The Watershed Alliance of Marin (WA)

The Watershed Alliance of Marin submitted a comment letter on the Meadow Way Bridge Replacement Project on the day of the Town meeting which the topic was to be voted on (May 6, 2020). Responses to those comments are provided below.

RE: Request for an Environmental Impact Report (EIR) for the Meadow Way Bridge replacement project and channelization of San Anselmo Creek

ATTACHMENT 1

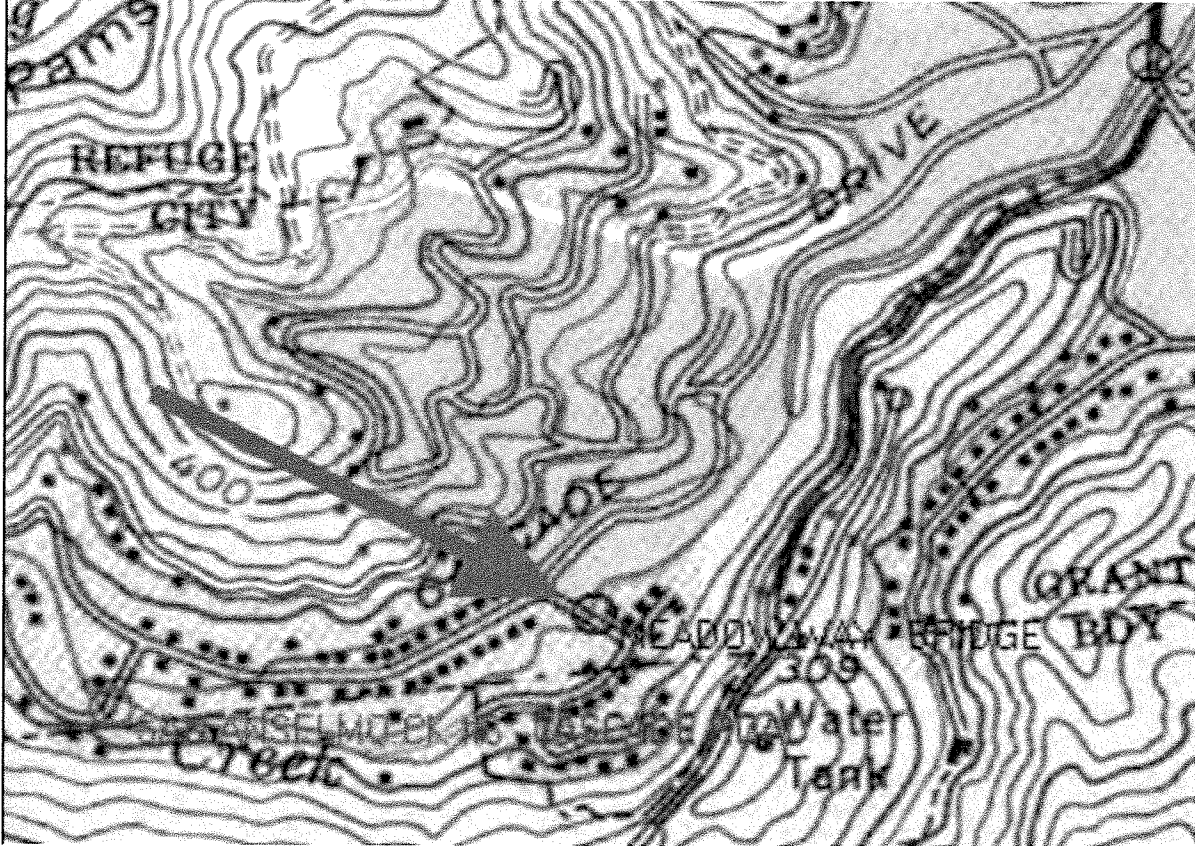
- The Meadow Way reach of San Anselmo creek is officially a perennial creek and not an intermittent creek as stated in the Initial Study and MND. Attached are multiple maps and definitions that verify this perennial creek status including those provided in the Sierra Club letter, USGS, National Wetlands Inventory, U.S. Geological Survey, Marin County Watershed Program, National Marine Fisheries Service (NMFS), EcoAtlas, CEMAR, Fisheries Biologist Alice Rich, etc. (multiple examples below in Attachments 1-5). The following definitions are pertinent:

US QUADRANGLE DETAIL SHOWS SAN ANSELMO CREEK AT MEADOW WAY BRIDGE TO BE A PERENNIAL CREEK.

The US Fish and Wildlife Service (USFWS) National Wetlands Inventory (NWI) is a publicly available resource that provides detailed information on the abundance, characteristics, and distribution of US wetlands. This database is used to inform project applicants and agencies of the nature of wetlands known in the area of a project. This database classifies the reach of San Anselmo Creek within the vicinity of Meadow Way Bridge as R4SBC, which is (R) riverine, (4) intermittent, (SB) streambed, (C) seasonally flooded. The NWI describes an intermittent stream as a “Subsystem [that] includes channels that contain flowing water only part of the year. When the water is not flowing, it may remain in isolated pools or surface water may be absent.” This description provided by the USFWS NWI was used to classify the stream and observations from site visits to the bridge by the biologists support that classification. Additionally, statements by local residents during the May 6, 2020 Town Council meeting for the Project also support the seasonal drying of the creek. Written comment letters on the Project and Final IS/MND also support the seasonality of the creek. Comment FE-7 in the WRA Memo dated May 1, 2020 states that the commenter has observed fish rescues at Meadow Way because the creek dries down and he has observed steelhead being moved downstream to sections of creek that do not dry out. Comment S-1 in the WRA Memo dated May 1, 2020 describes San Anselmo Creek as drying down in the summer with no surface flow and disconnected pools. All such descriptions support the description provided by the USFWS in the NWI. Therefore, the classification of San Anselmo Creek as intermittent is supported by numerous sources. In addition, this question has been addressed by previous comments received by the Project in response to comment SC-5 in the WRA Memo dated May 1, 2020.
